UNITED STATES PATENT AND TRADEMARK OFFICE

APPLICATION NO.	FILING DATE	FIRST NAMED INVENTOR	ATTORNEY DOCKET NO.	CONFIRMATION NO.
10/582,209	06/09/2006	Rainer Brachert	2003P01907WOUS	3969

Office Action Summary	Application No. 10/582,209	Applicant(s) BRACHERT, RAINER	
	Examiner DAN ROHRHOFF	Art Unit 3637

DETAILED ACTION

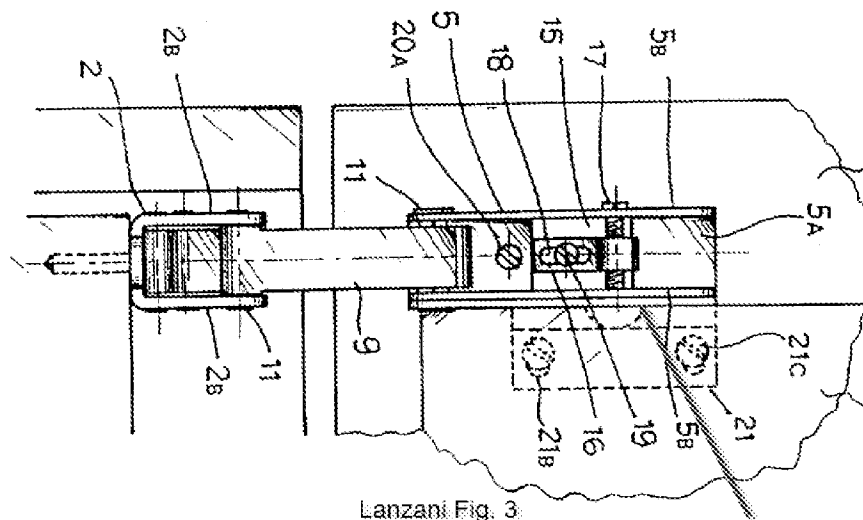
26. Regarding the argument that inserting shims between the door and the hinge would adjust the door in a horizontal direction, the examiner disagrees. Inserting a plurality of shims between the supporting surfaces of the upper and lower hinges (as

indicated in the rejection of claim 15 above) and the door would provide for a change in the vertical position of the door relative to the body. The horizontal adjustment as pointed out by the applicant would be made if the plurality of shims were inserted between the door and the front panel.

27. Regarding the argument the office fails to explain how a plurality of shims could be inserted between the supporting surfaces of the hinges and the door to adjust the door in a vertical direction are not persuasive. Additionally, the figure below points out where the shim would be inserted between supporting surfaces of the hinges and the door to provide for vertical adjustability.
